**TOWN OF LOS GATOS  
PLANNING COMMISSION  
REPORT**

DATE: March 21, 2025  
TO: Planning Commission  
FROM: Joel Paulson, Community Development Director  
SUBJECT: Consider a Request for Approval to Construct a New Single-Family Residence and Site Improvements Requiring a Grading Permit on Vacant Property Zoned HR-1. **Located at 16497 S. Kennedy Road.** APN 532-17-038. Architecture and Site Application S-24-037. Categorically Exempt Pursuant to CEQA Guidelines Section 15303: New Construction. Property Owner: Robert Nicol. Applicant: Chris Spaulding. Project Planner: Jocelyn Shoopman.

**RE: 16497 South Kennedy Drive**

**Two story wall segment would appear to not be consistent with both the Hillside Design Standards and Guidelines and the Town's Residential Design Guidelines**

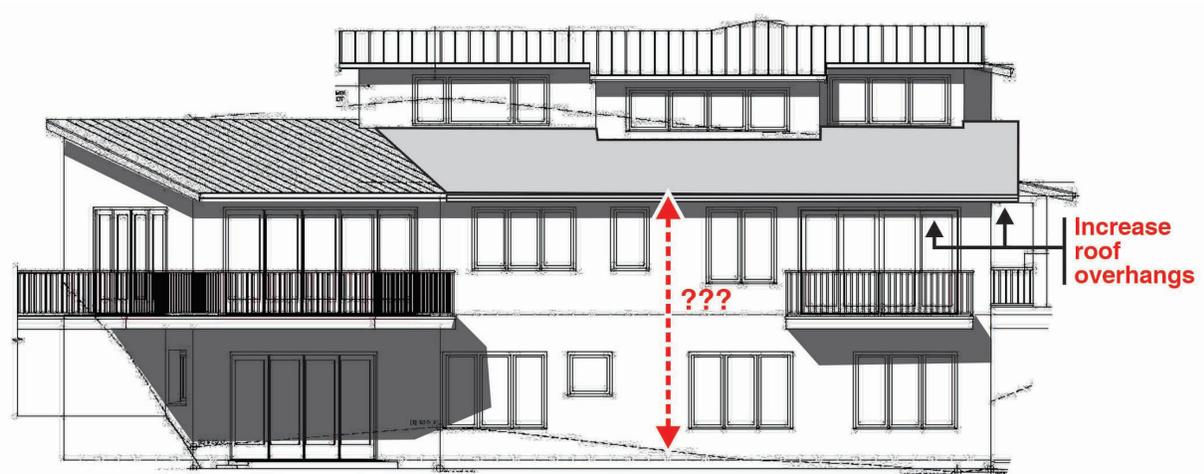
1. Increase the roof overhang to provide a stronger eave shadow line to mitigate the two story facade.
2. There may be two ways to address the issue of the two story flat downhill facade section:
  - A. Leave it as proposed given the amount of downhill landscaping that is currently a buffer to views from the home below and the applicant's commitment to plant screen landscaping at the lower property line.

- B. Extend the balcony across the facade connecting the currently proposed balcony and deck.

**Two story wall segment would appear to not be consistent with both the Hillside Design Standards and Guidelines and the Town's Residential Design Guidelines**

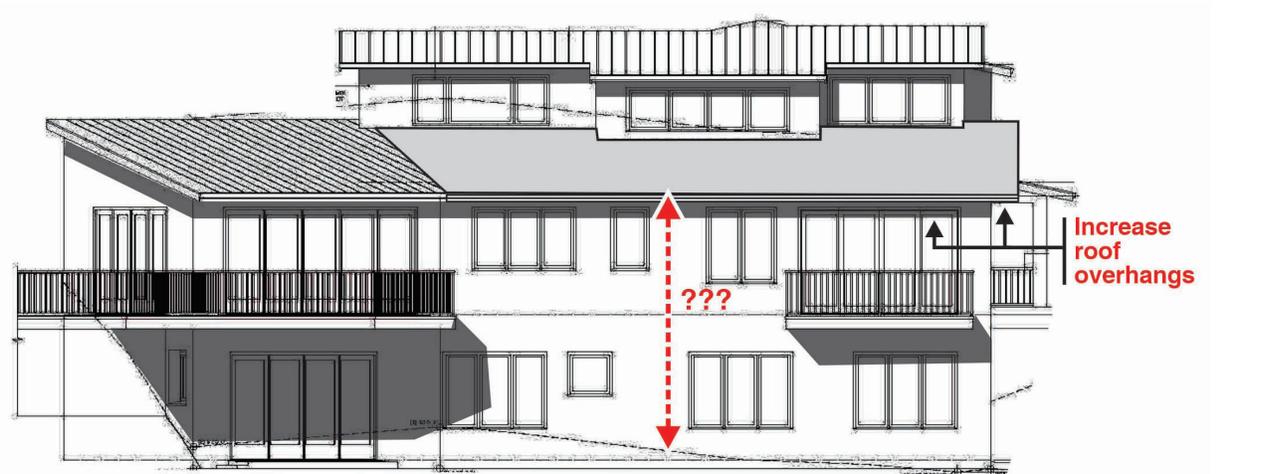
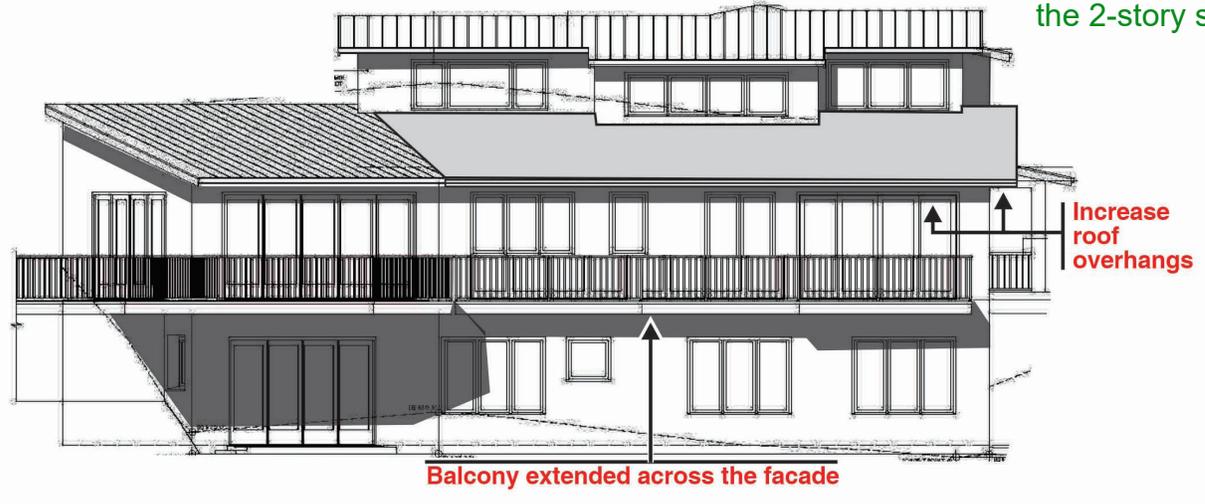
1. Increase the roof overhang to provide a stronger eave shadow line to mitigate the two story facade.  
**The eaves have been lengthened over the area with the 2-story facade**
2. There may be two ways to address the issue of the two story flat downhill facade section:
  - A. Leave it as proposed given the amount of downhill landscaping that is currently a buffer to views from the home below and the applicant's commitment to plant screen landscaping at the lower property line.

- B. Extend the balcony across the facade connecting the currently proposed balcony and deck.  
**The middle floor has been cantilevered out 18" to between the balconies to break up the 2-story section**

**A2**  
 OF 9 SHEETS

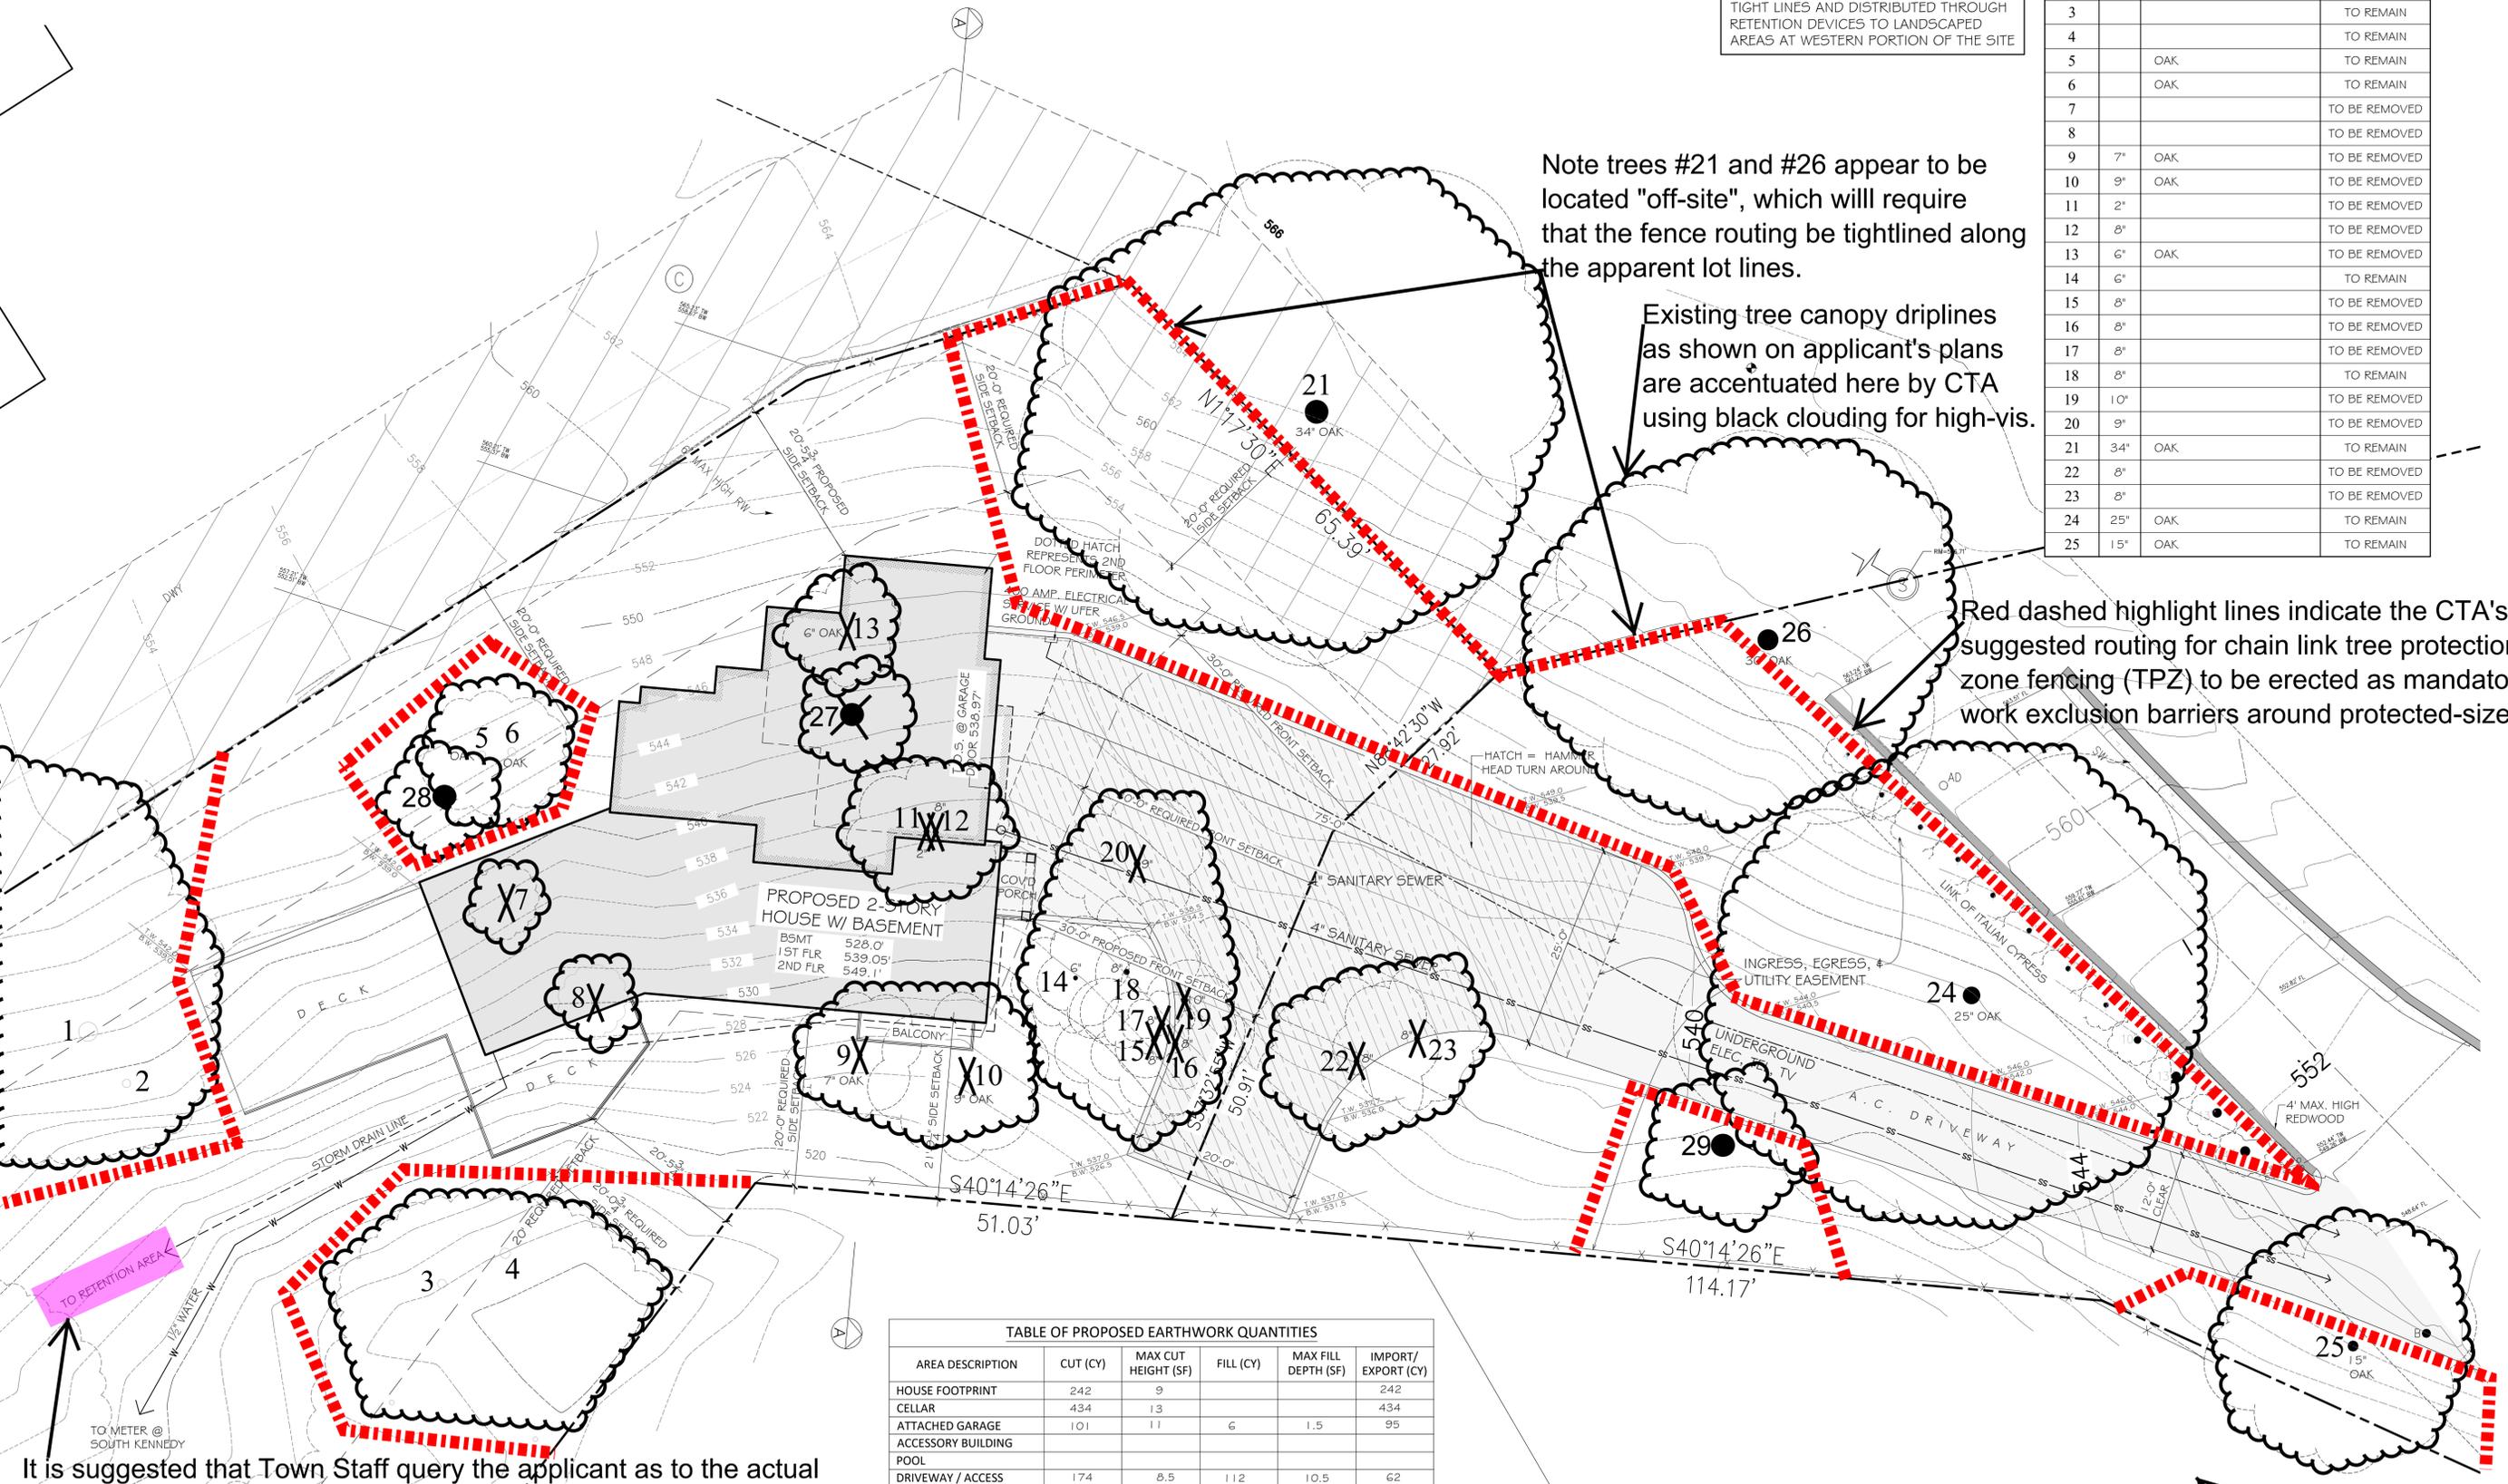
- **UNKNOWN FACTOR / STORMWATER CONVEYANCE SYSTEM PROPOSED:** the westmost end of the proposed storm drain pipeline trench indicated on applicant sheet A2 as "to retention area" is an unknown factor.

Town Staff will need to query the applicant team regarding this item, given that the area west of the west edge of sheet A2 was not surveyed by the CTA (the CTA was directed by Town Staff to survey only those site areas in immediate vicinity of proposed work. Therefore, all existing native oak specimens west of trees #1 and #2 have not yet been assessed to determine impacts related to proposed site work, as of the date of this CTA arborist report writing).

It is likely that there is a proposed stormwater retention basin and/or proposed storm drain pipe outfall with rock dissipater not being shown on the applicant's set of plans as of the date of writing, proposed to be built in the (as yet unassessed) native oak forest area west of the west edge of plan sheet A2.
